HISTORIC AND DESIGN REVIEW COMMISSION

HDRC CASE NO: 2022-271
ADDRESS: 1933 W MULBERRY AVE
LEGAL DESCRIPTION: NCB 1944 BLK 22 LOT 9
ZONING: R-6, H
CITY COUNCIL DIST.: 7
DISTRICT: Monticello Park Historic District
APPLICANT: Jennifer Stimmel/Statewide Remodeling.
OWNER: Rudy Blanco/BLANCO RUDY L & GUADALUPE
TYPE OF WORK: Window replacement
APPLICATION RECEIVED: May 04, 2022
60-DAY REVIEW: Not applicable due to City Council Emergency Orders
CASE MANAGER: Rachel Rettaliata

REQUEST:

The applicant is requesting a Certificate of Appropriateness for approval to replace ten (10) original wood windows with vinyl windows.

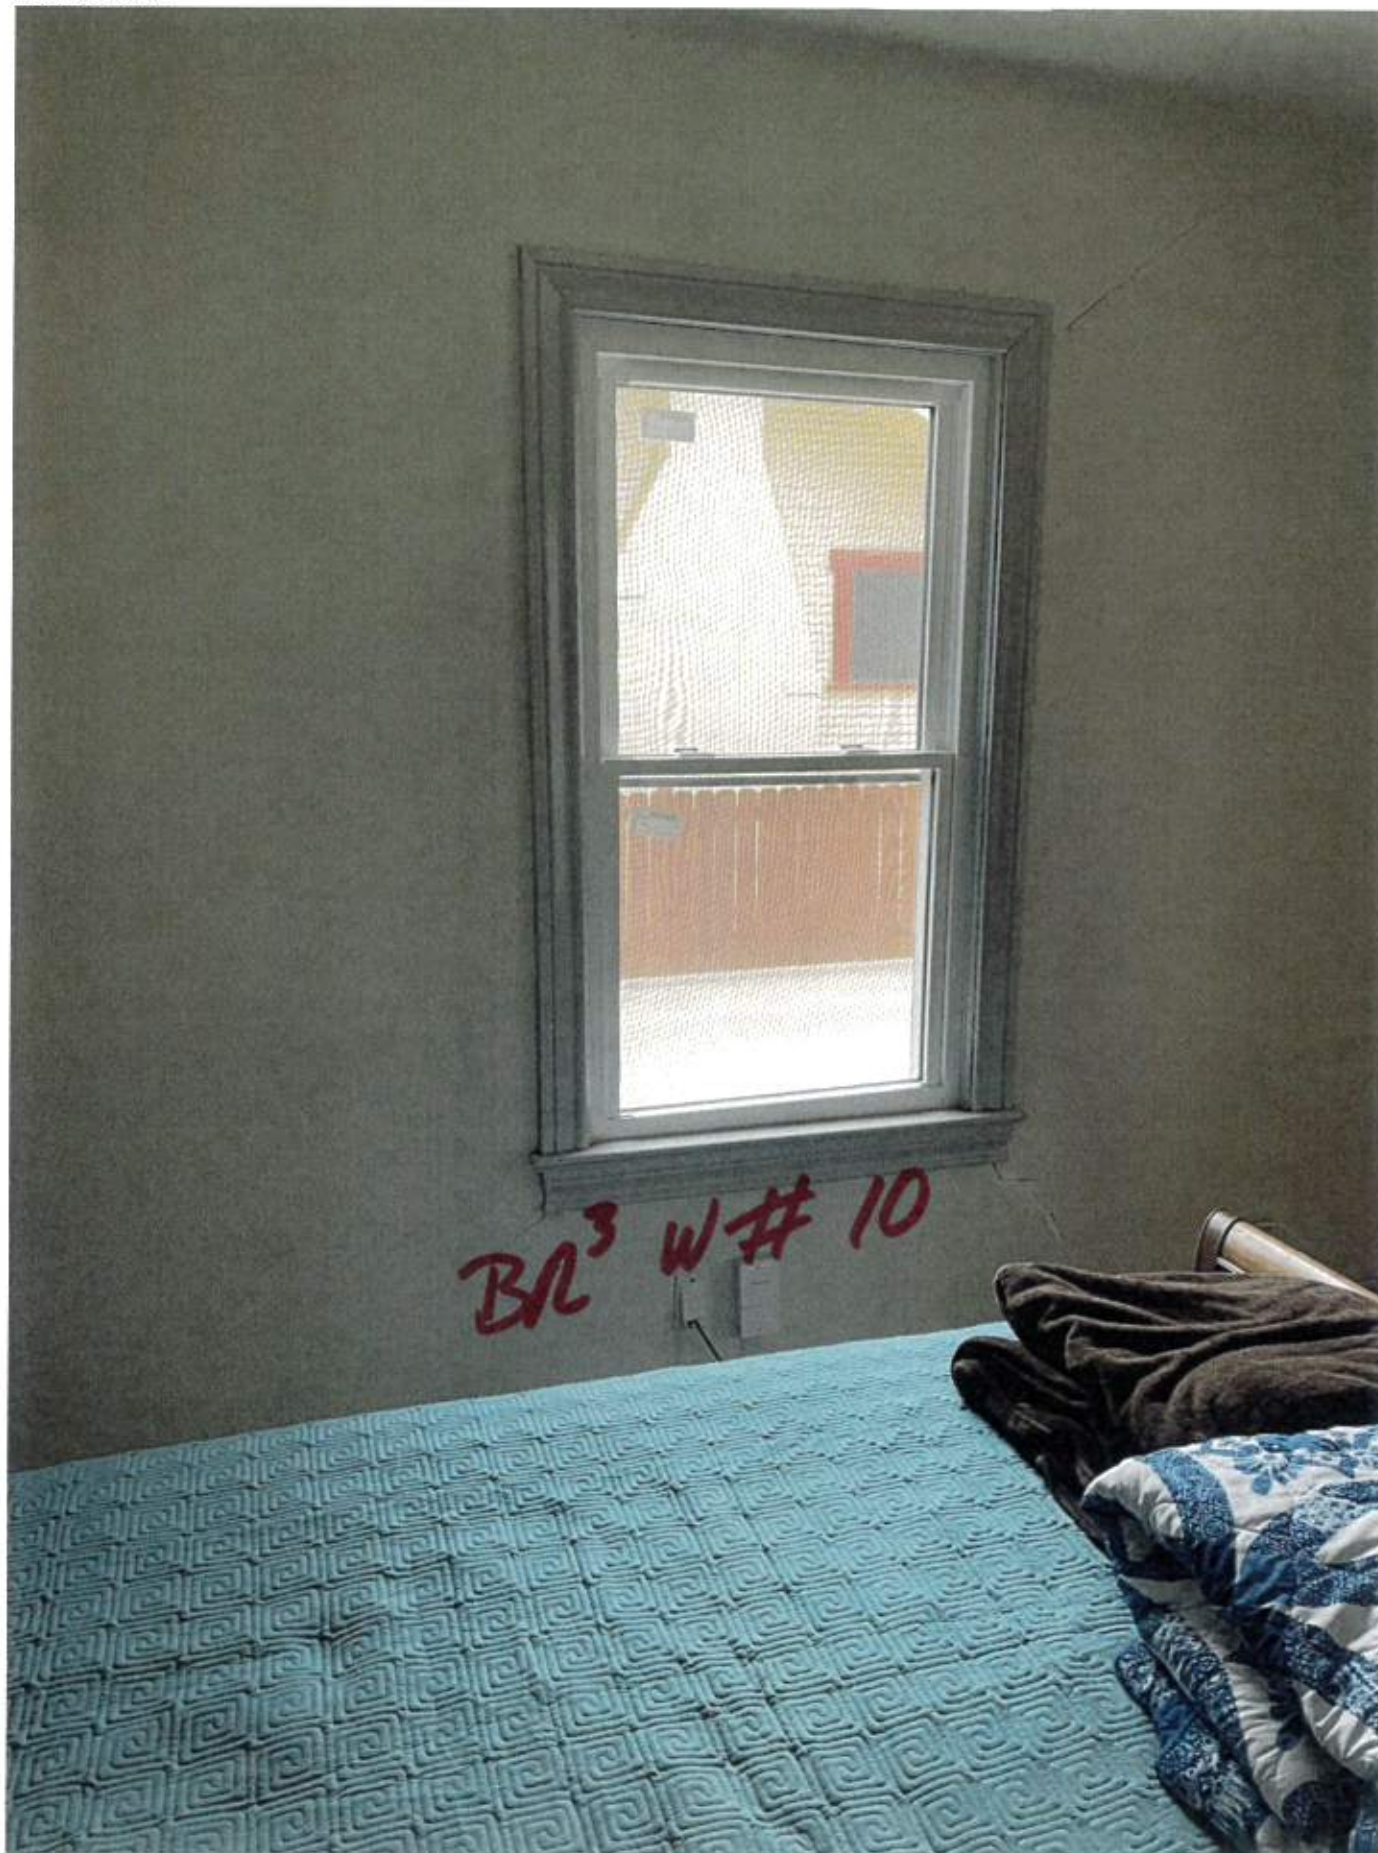
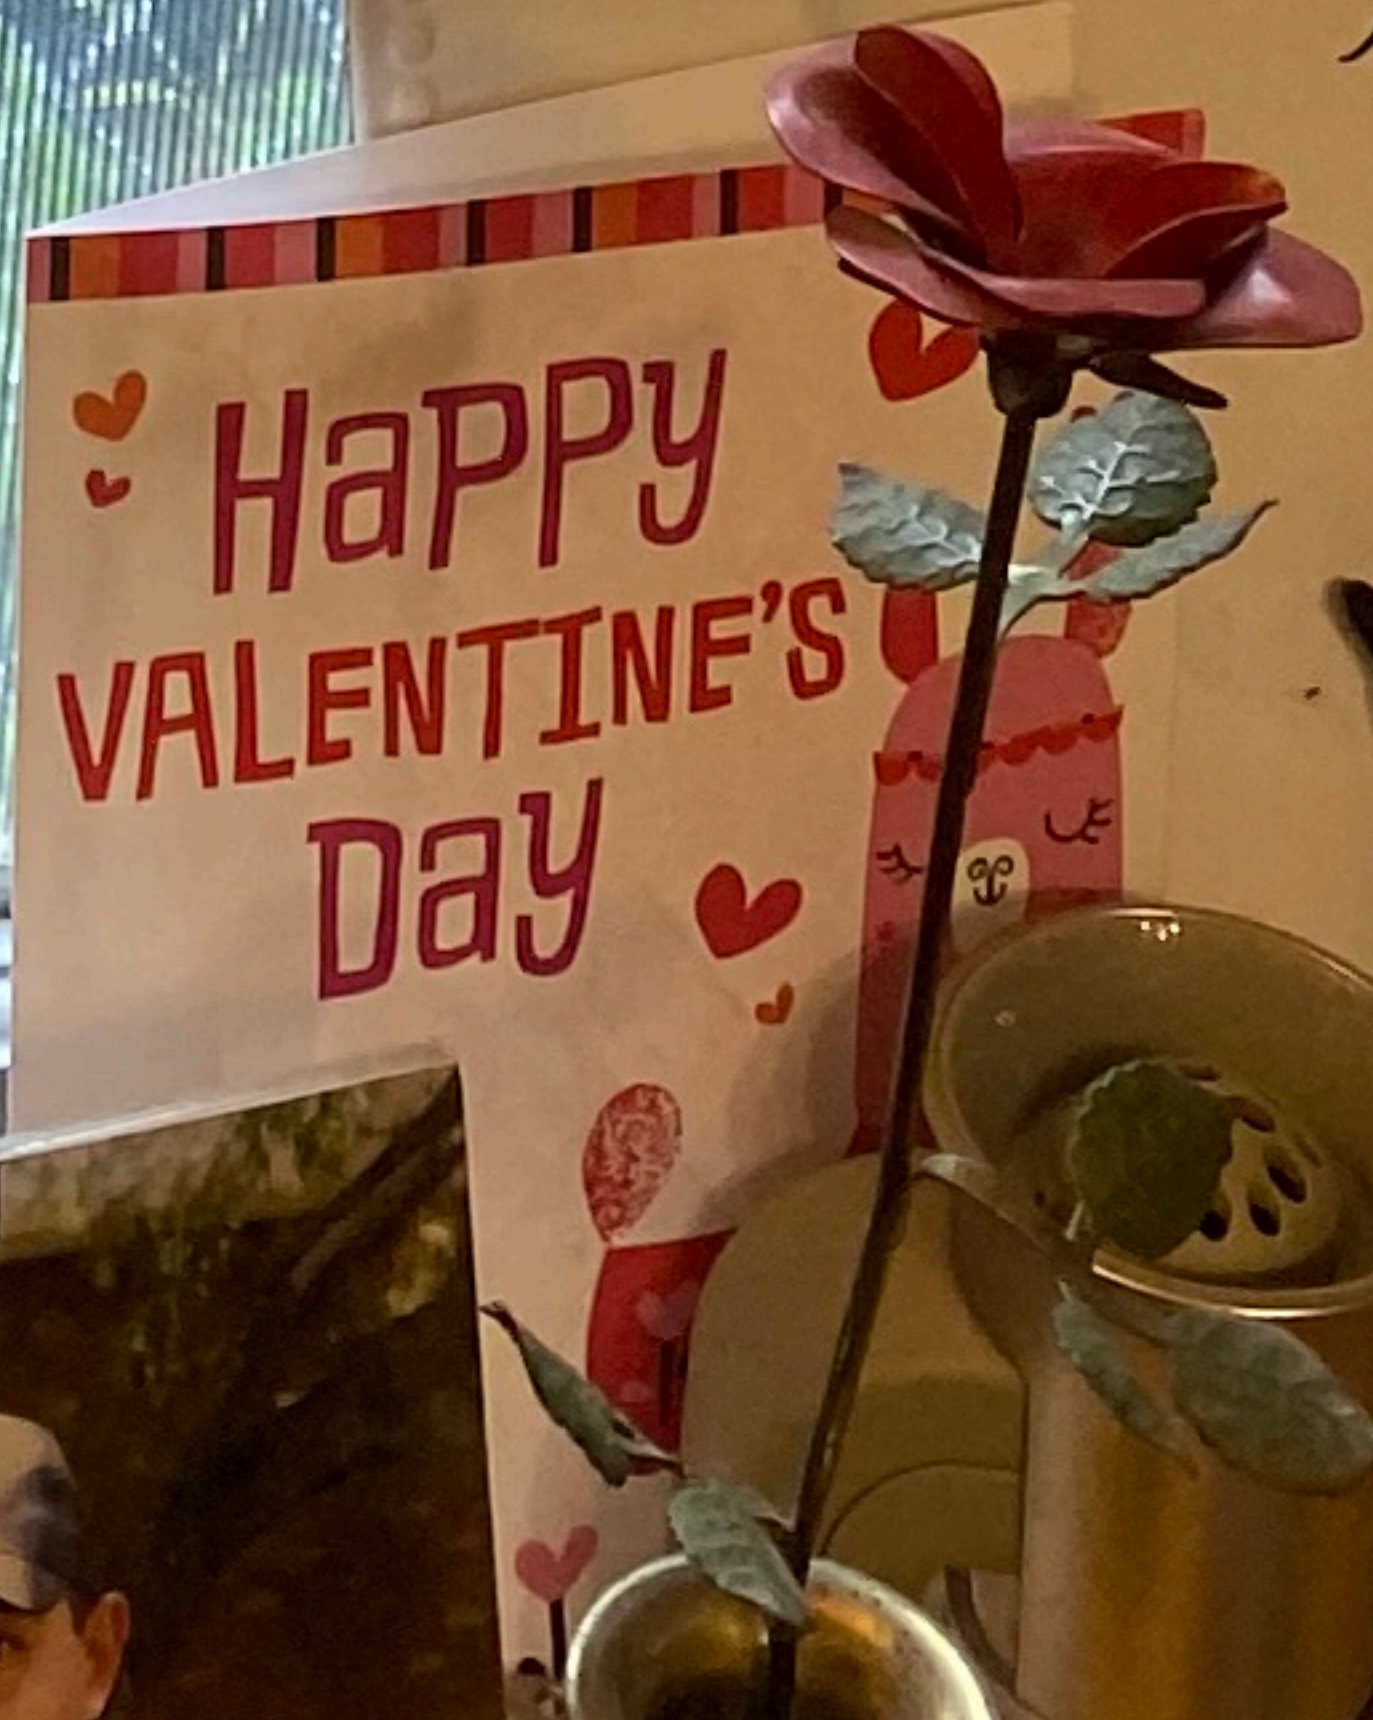
- c. WINDOW REPLACEMENT: EXISTING CONDITION – Staff conducted a site visit on May 5, 2022, and observed the following conditions on the remaining original wood windows: damaged and peeling or chipping paint, broken or missing cords, and loose or broken glass. Some of the existing windows may require reglazing or the reworking of the sashes. The windows do not show signs of significant wood rot, wood damage, or severe deterioration. Staff finds that all remaining wood windows are in repairable condition, with most requiring

- f. **WINDOW REPLACEMENT** – The applicant has proposed to replace ten (10) existing wood windows with vinyl replacement windows. According to the Historic Design Guidelines, wood windows should be repaired in place and restored whenever possible, unless there is substantial evidence that the windows are deteriorated beyond repair. Guideline 6.B.iv for Exterior Maintenance and Alterations states that new windows should be installed to match the historic or existing windows in terms of size, type, configuration, material, form, appearance, and detail when original windows are deteriorated beyond repair. As noted in finding b, staff finds that the windows are in repairable condition, with a majority of them being covered and protected over the past few decades by exterior screens, and that the replacement product is not appropriate or consistent with the Guidelines.

Staff does not recommend approval based on findings a through f.

- i. That the applicant installs fully wood windows that meet staff's standard window stipulations and submits updated specifications to staff for review and approval. The windows should feature an inset of two (2) inches within facades and should feature profiles that are found historically within the immediate vicinity. Meeting rails must be no taller than 1.25" and stiles no wider than 2.25". White manufacturer's color is not allowed, and color selection must be presented to staff. There should be a minimum of two inches in depth between the front face of the window trim and the front face of the top window sash. This must be accomplished by recessing the window sufficiently within the opening or with the installation of additional window trim to add thickness. Window trim must feature traditional dimensions and architecturally appropriate sill detail. Window track components must be painted to match the window trim or concealed by a wood window screen set within the opening.
